Chandos Street Noise Wall Installation

Submission report

Roads and Maritime Services | April 2019

Figure 2-1: Ownership of land at the end of Chandos Street

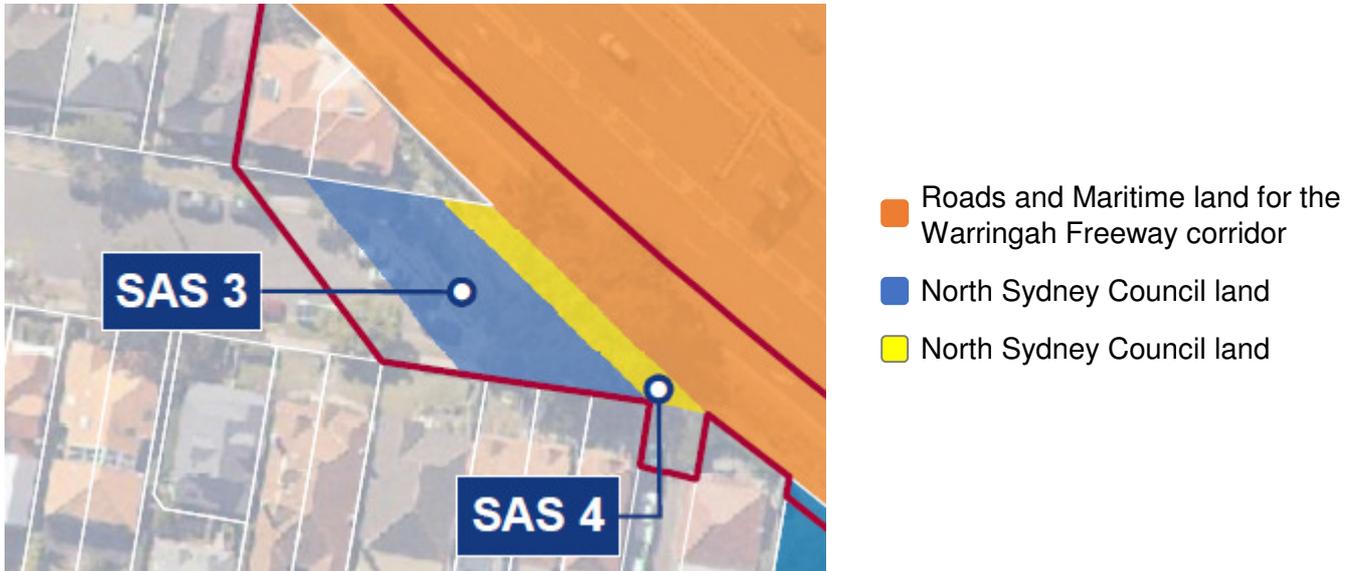
One submission was received regarding the ownership of land at the end of Chandos Street and concern that exclusive access to the land at the end of Chandos Street will be lost. (6)

Roads and Maritime have identified that the land at the end of Chandos Street falls under North Sydney Council ownership (see Figure 2-1)

Fencing would be reinstated to prevent unauthorised access to North Sydney Council land at the end of Chandos Street. It is proposed that this land would be returned to North Sydney Council to maintain.
